ADVISORY PLAN COMMISSION AGENDA

MARCH 16, 2026

1. **PSDP-25-12 KARAM CONVENIENCE CENTER DEVELOPMENT PLAN REVIEW**

2. **PSDP-26-2 RESERVE AT RONALD REAGAN INFRASTRUCTURE DEVELOPMENT PLAN REVIEW**

SHEET NO:
C205

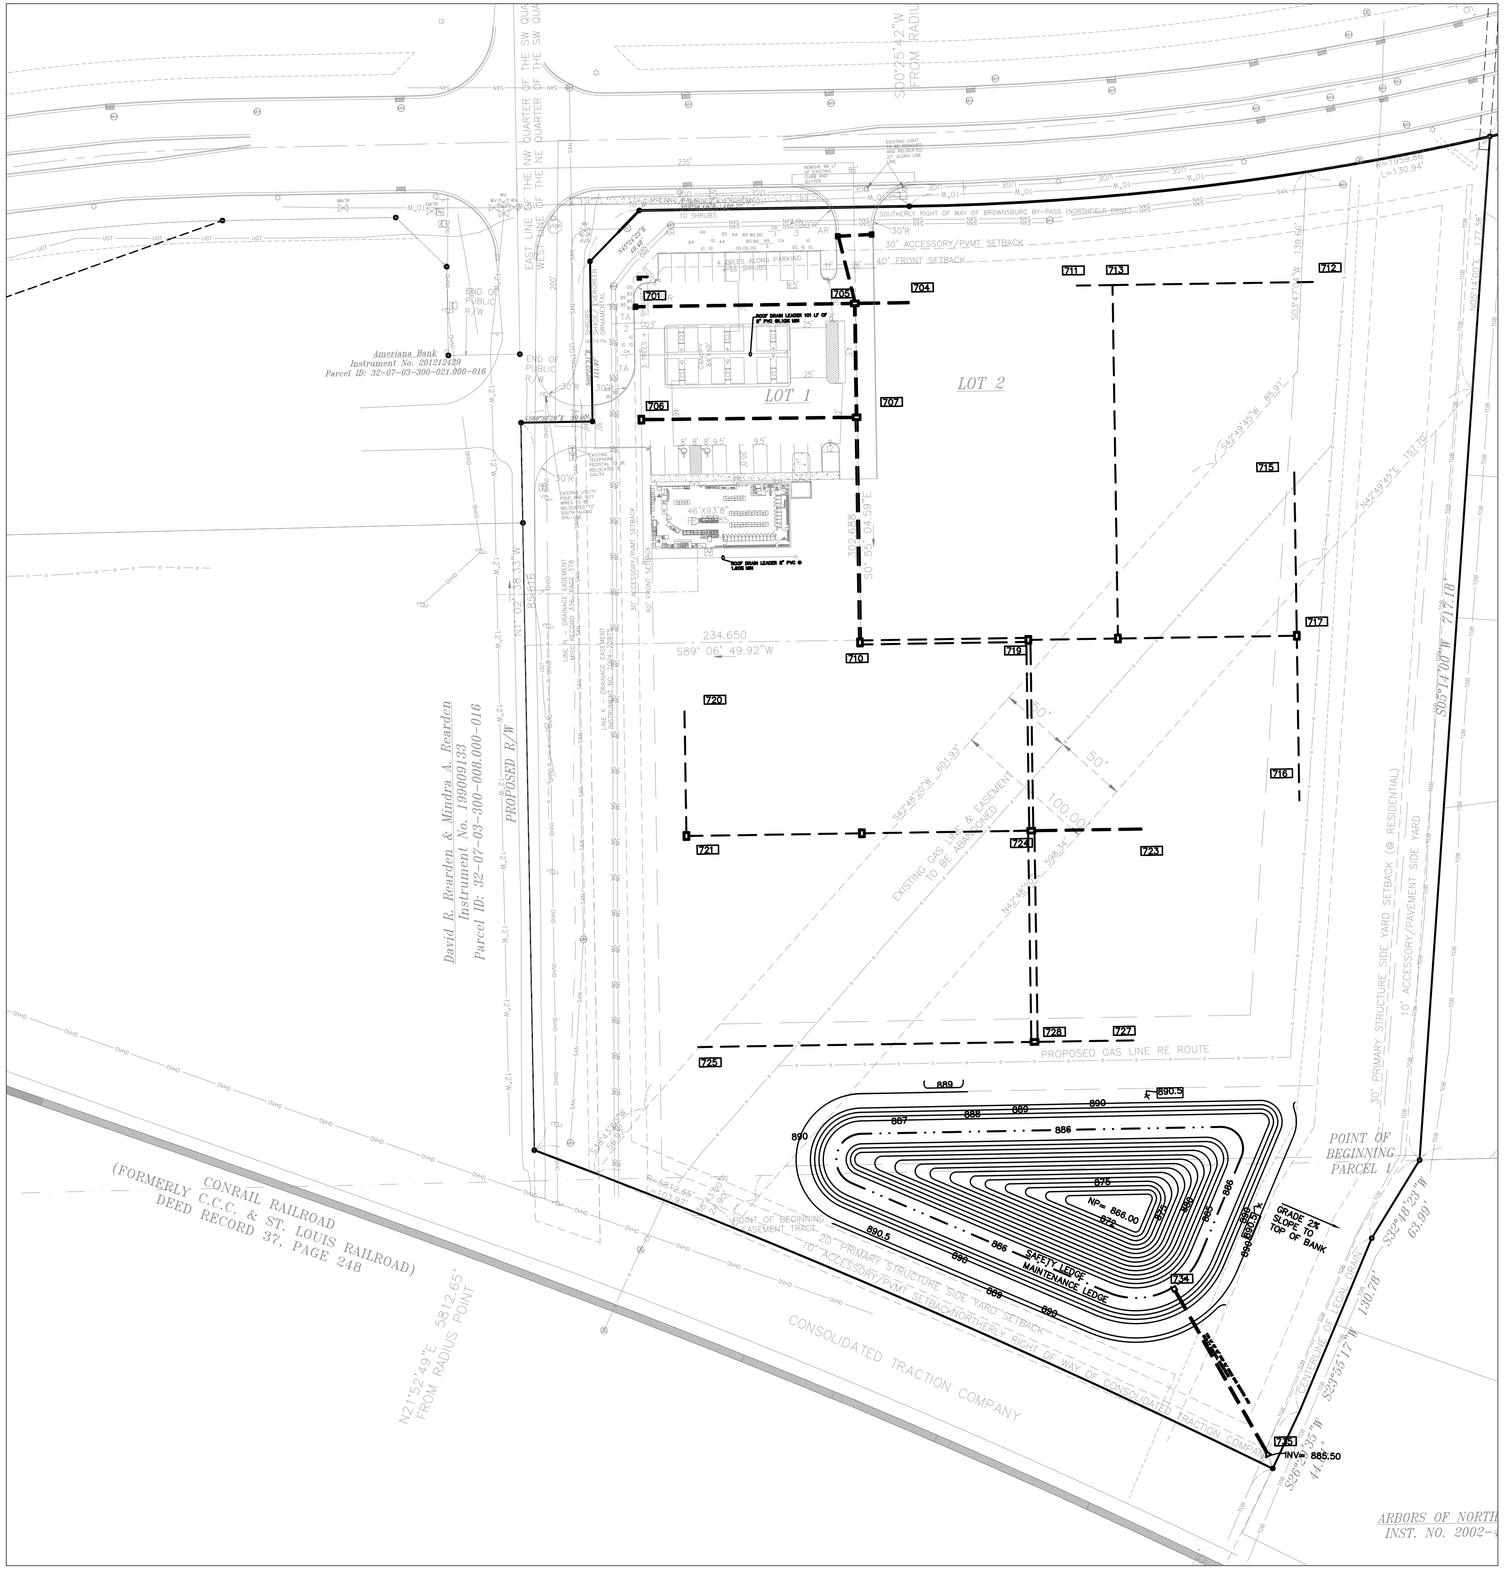
- A24: There is not a plan sheet in the submittal detailing proposed grading, elevations or contours.
- A25: Sheet C205 is not included in the submittal.

- B14/B15: Sections B14 and B15 appear to be addressed on the left side of Sheet C205 however the SWPPP does not refer to this section. Update accordingly.

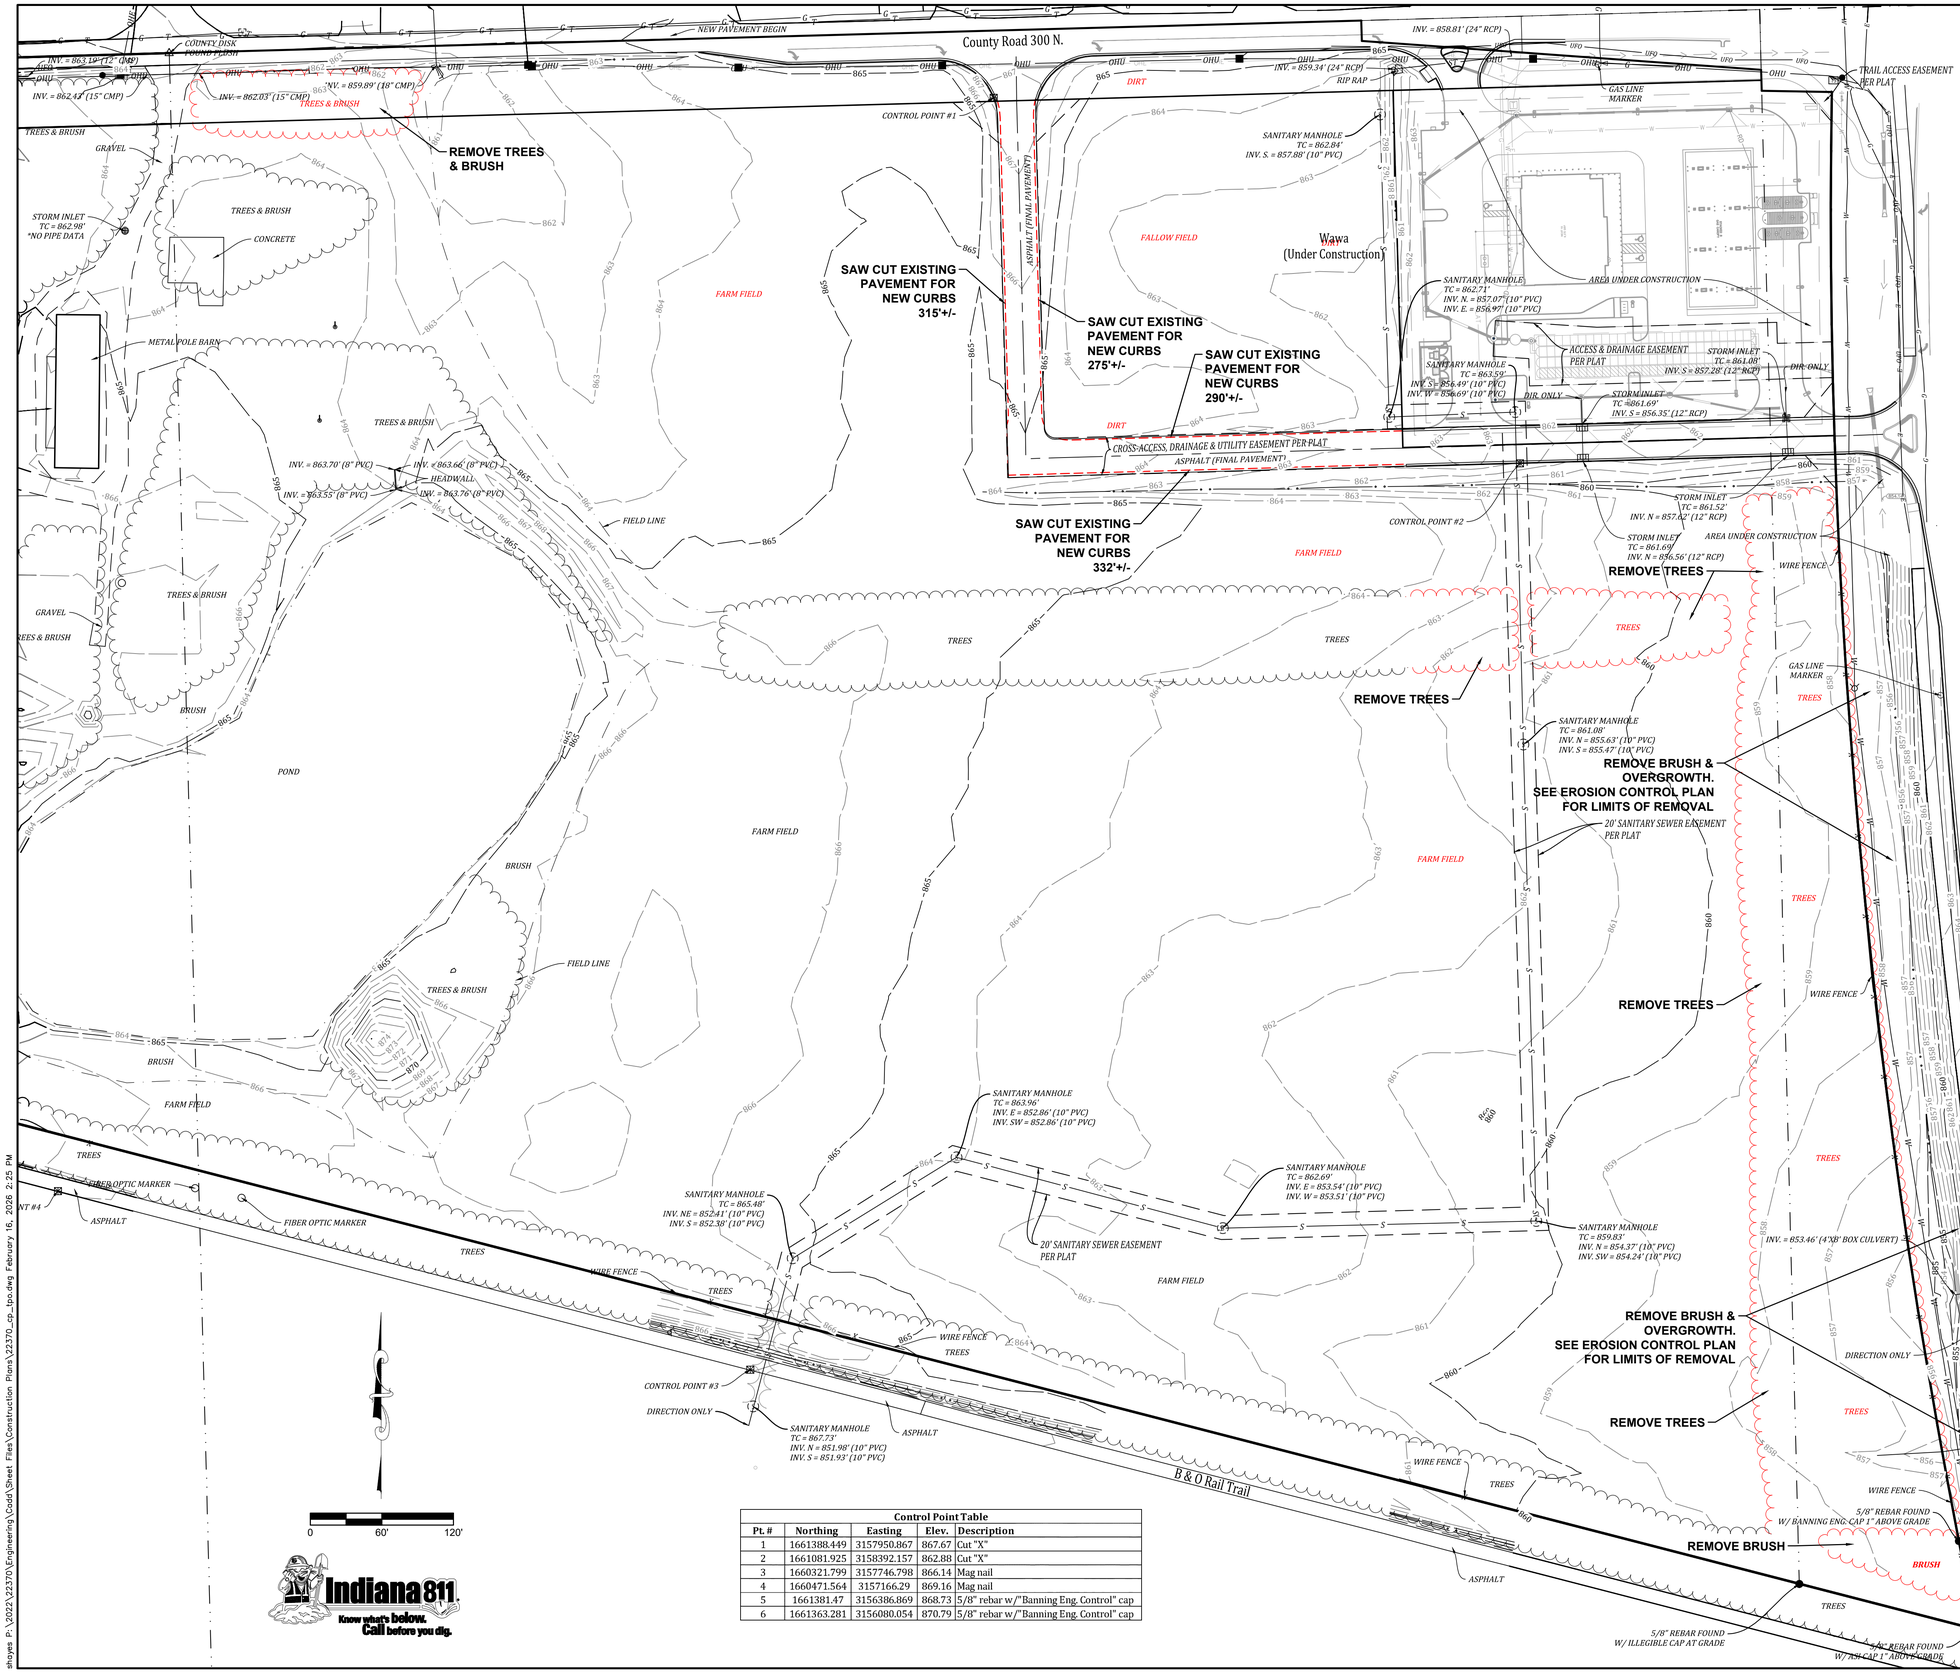
a) Sheet C100 incorrectly lists location in Brown Township. This location is located in Lincoln Township POLICE

8) **FIRE TERRITORY**
   a) Sheet C100 incorrectly lists location in Brown Township. This location is located in Lincoln Township POLICE Sheet C100has been corrected to Lincoln Township.
   b) Water main sheets C330-C332. Servicing fire department should be Brownsburg Fire Territory. The fire territory has been corrected.

DRAWING NO.
C1.1

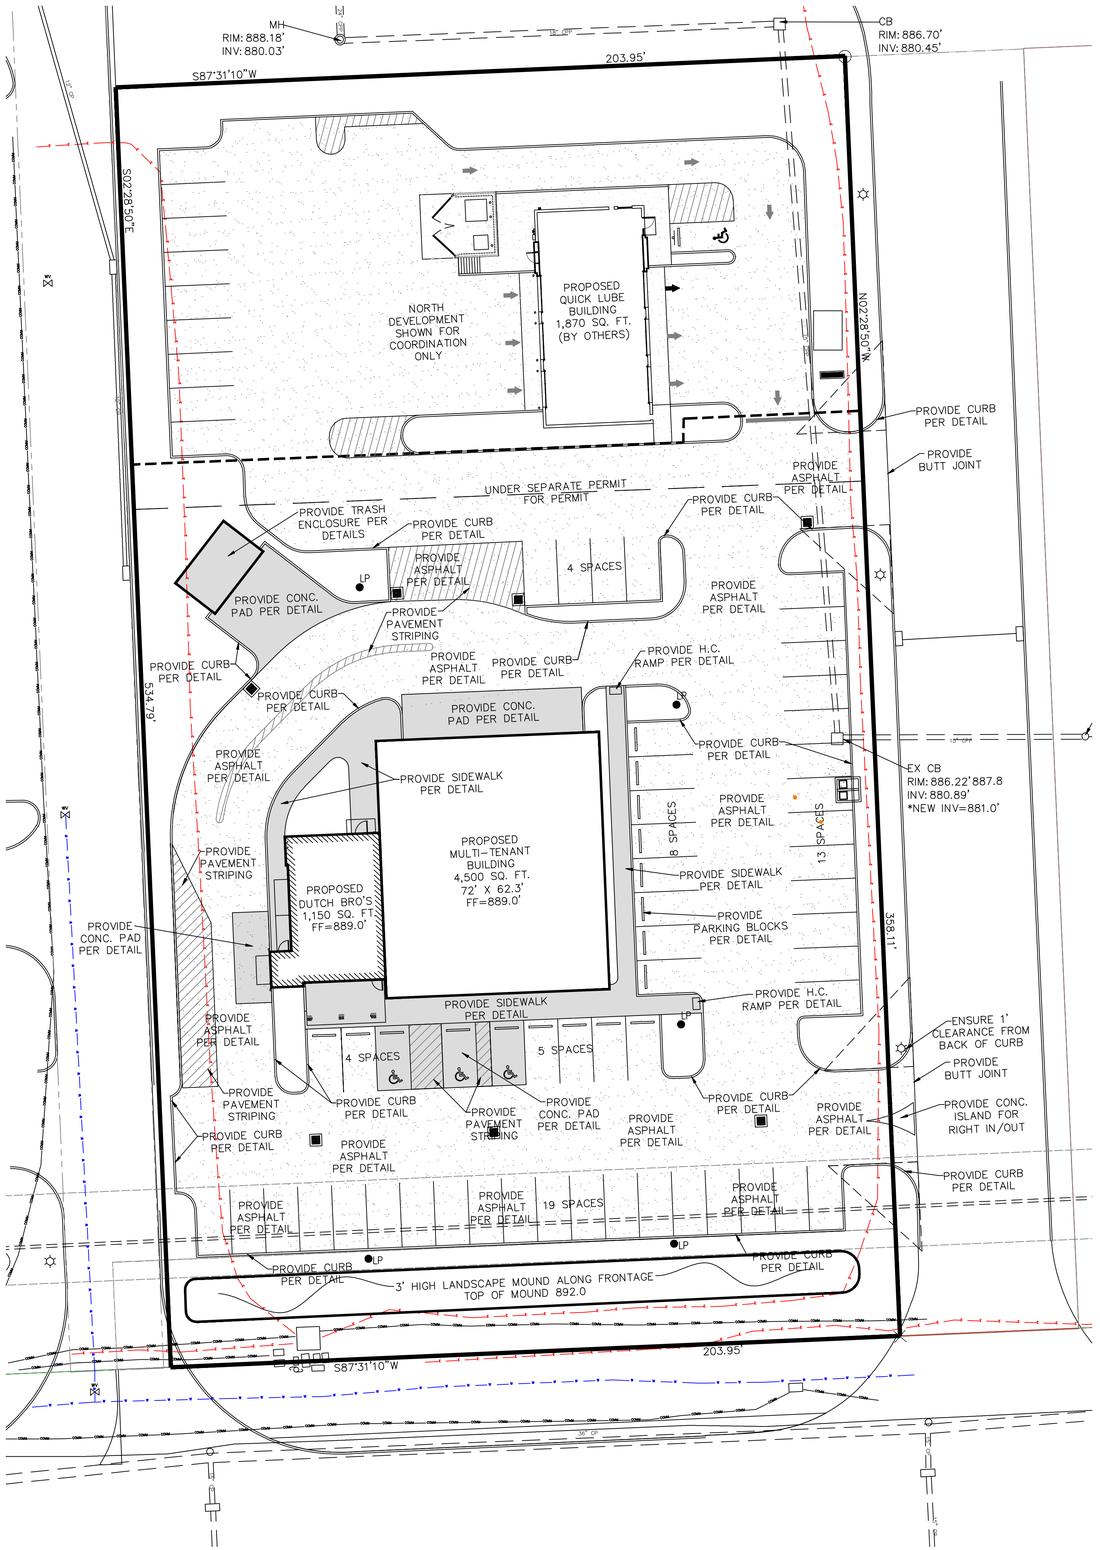
- The EPSC Notes on Sheet C1.1 references the City of Indianapolis standards. This submittal should follow the requirements of the Town of Brownsburg Chapter 151 Stormwater Management Ordinance and the Town of Brownsburg Construction Standards.
- Include the following per the Town of Brownsburg Ordinance and Standards:
    - The Town of Brownsburg reserves the right to require additional onsite controls as deemed necessary to maintain compliance with the Construction Stormwater General Permit (CSGP) and the Town's Stormwater Management Ordinance. All erosion and sediment controls, best management practices and pollution prevention measures must be installed and maintained in accordance with the Indiana Stormwater Quality Manual.
    - Submit notice of termination (NOT) inspection request to Town prior to filing NOT with IDEM.
